The Secretary
NSW Department of Planning, Industry and Environment

23 August 2020

I refer to the Department's below email of 14 August 2020 regarding the Environmental Impact Statement (EIS) for State Significant Development SSD-10477 Sydney Business Park - Stage 3 for construction and operation of Stage 3 of Sydney Business Park. Comprising of four Warehouse and Distribution Centres, roads and infrastructure located at Hollinsworth Road and Astoria Street, Marsden Park (Part Lots 4 and 5 DP 1210172 and Part Lot 36 DP 262886) in the Blacktown City LGA. Submissions need to be made to the Department by 17 September 2020.

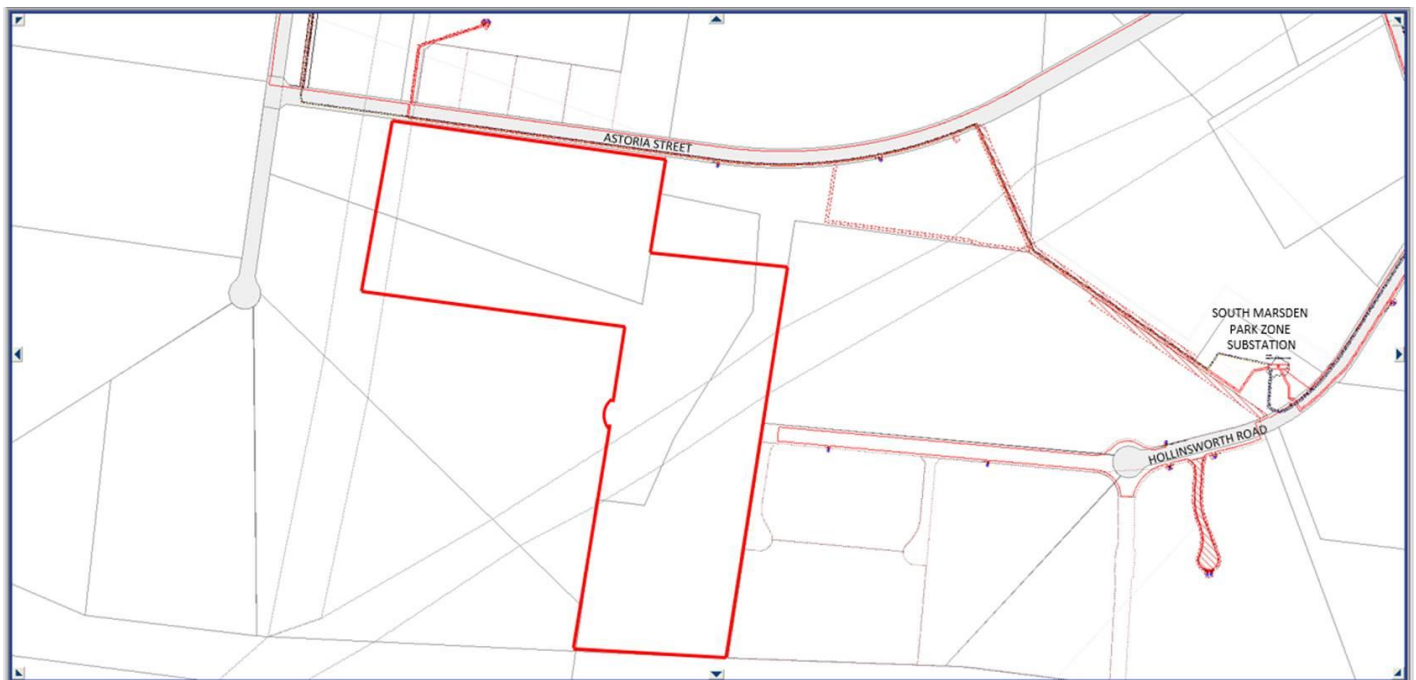
Endeavour Energy has also noted that as shown in the following extract of the WH4 – Site Plan that provision has been made for two padmount substations. From Endeavour Energy's perspective the fact that provision is being made for the substation is a positive Endeavour Energy's general requirements is for a padmount substation be at ground level and have direct access from a public street unless it is provided with a suitable right of access and with an easement for the associated underground cables.

In regard to the proximity of the 'Diesel Generator Refueling Place' to the padmount substations, Endeavour Energy is aware that the provisions of State Environmental Planning Policy No 33— Hazardous and Offensive Development (SEPP33) in the preparation of a preliminary hazard assessment electricity infrastructure is not defined / regarded as sensitive land use. However, in similar situations Endeavour Energy has sought further advice from the consultants preparing the preliminary hazard assessment on the basis that, although not a sensitive land use in the traditional / environmental sense, if the electricity infrastructure on or in proximity of the site (which also may be a potential ignition source) is damaged, the resulting outage could leave many properties / customers without power. The consultants have been requested to specifically address the risks associated with the proximity of the electricity infrastructure ie. detail design considerations, technical or operational controls etc. to demonstrate as required by SEPP33 that the proposed business / development is suitably located and can be built and operated with an adequate level of safety and pollution control. Endeavour Energy's recommendation is that the separation distance be increased to as far as reasonably possible to minimise any potential risk.

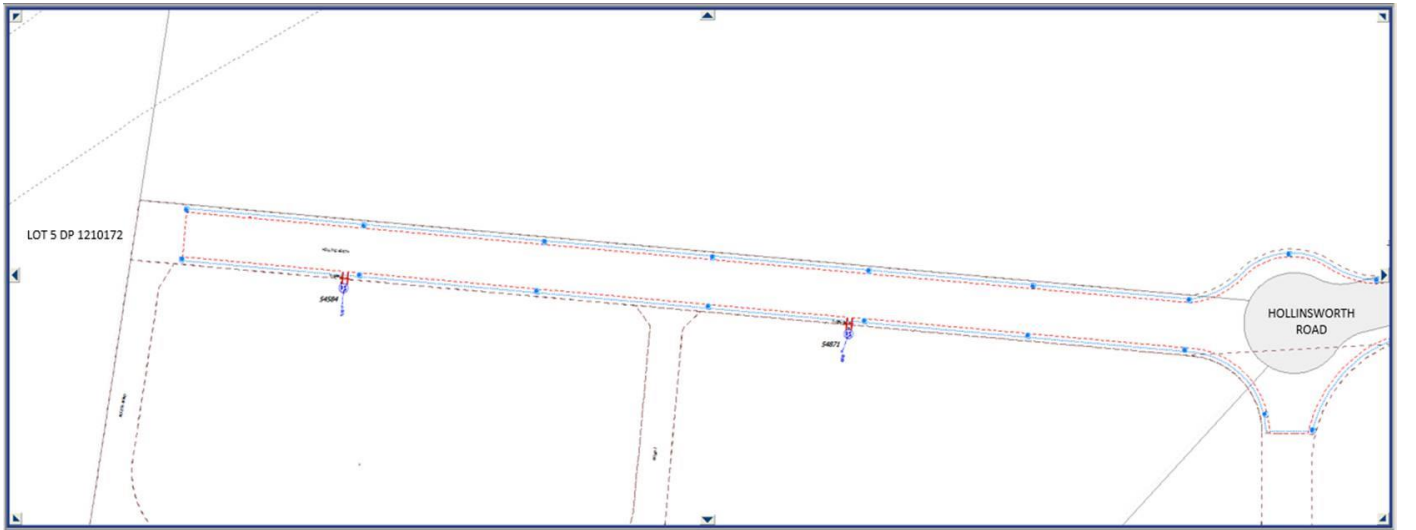
As shown in the below site plan from Endeavour Energy's G/Net master facility model in regard to Stage 3 there are:

- No easements benefitting Endeavour Energy (active easements are indicated by red hatching with the blue hatching indicating a 'Retired Property' / released easement).
- 11,000 volt / 11 kilovolt (kV) high voltage and 132,000 volt / 132 kV high voltage underground cables, underground earth cables and underground pilot cables (carrying protection signals or communications between substations) to the Astoria Street road verge / roadway.
- Low voltage and 11 kV high voltage underground cables to the road verge / roadway for the extension of Hollinsworth Road.
- It is in proximity of Endeavour Energy's South Marsden Park Zone Substation located at Hollinsworth Road Marsden Park (Lot 100 DP 1188147).

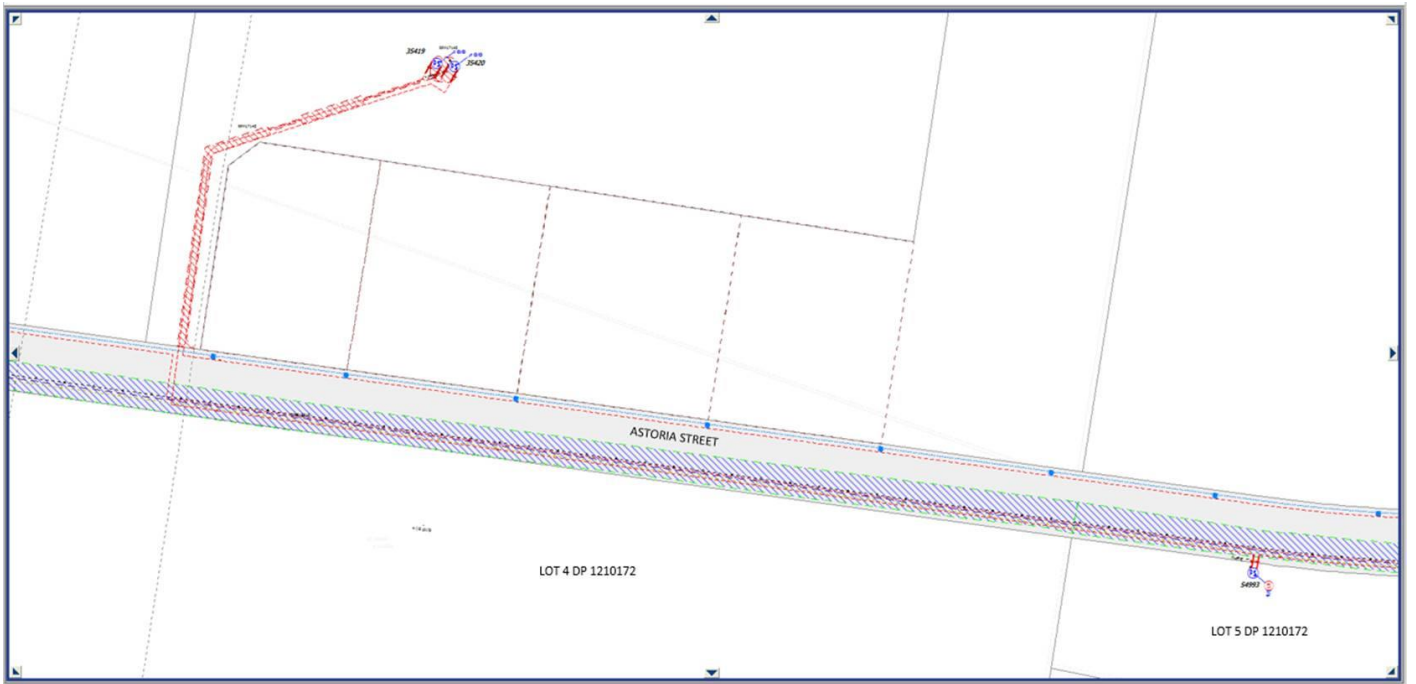
Endeavour Energy has noted that as shown in the following extract of Blacktown City Council's online mapping system that part of Stage 3 is within a bushfire zone.

Although industrial uses are not covered by Chapters 5 to 7 of NSW Rural Fire Service 'Planning for Bush Fire Protection 2019' (PBP), the aim and objectives of PBP still need to be considered and a suitable package of bush fire protection measures should be proposed commensurate with the assessed level of risk to the development. PBP provides the following advice regarding electricity services:
